PROPOSAL TO INSTALL PEDESTRIAN FENCING ON ANZAC PARADE, KINGSFORD NORTH OF THE ROUNDABOUT AT RAINBOW STREET

Issues Report

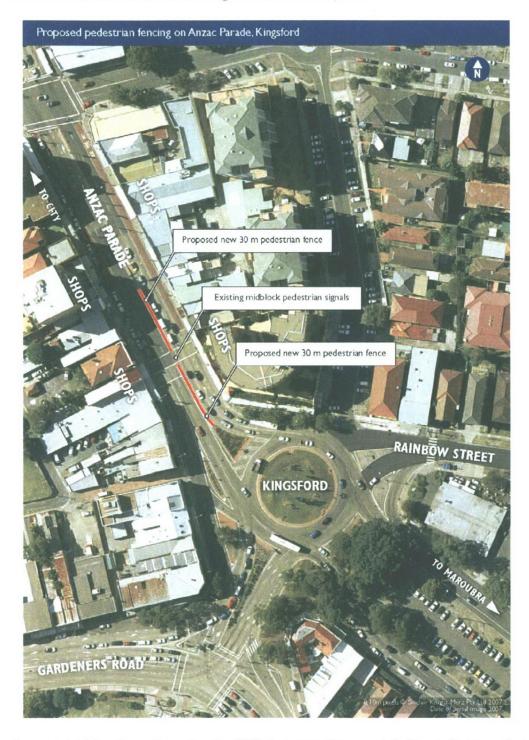
A pedestrian fence is proposed – two 30 metre sections on either side of the traffic lights. The southern section of the fence would extend from the roundabout at Rainbow Street to the mid-block pedestrian controlled traffic lights. The northern section of the fence would extend from the mid-block traffic lights to the concrete base of the directional sign structure. See map below.

• Business operators and residents noted that a number of pedestrians cross Anzac Parade through the garden bed adjacent to the roundabout and the fence would not stop this behaviour and requested that the fence be extended.

As suggested by the community, the RTA has agreed to extend the southern section of the fence by approximately 14 metres along the western edge of the triangular garden bed to the roundabout. This means the southern section of the pedestrian fence will be 44 metres long. The northern section will remain as proposed, 30 metres.

The scope of the project will now extend the pedestrian fence a further 14 metres to the western edge of the garden bed.
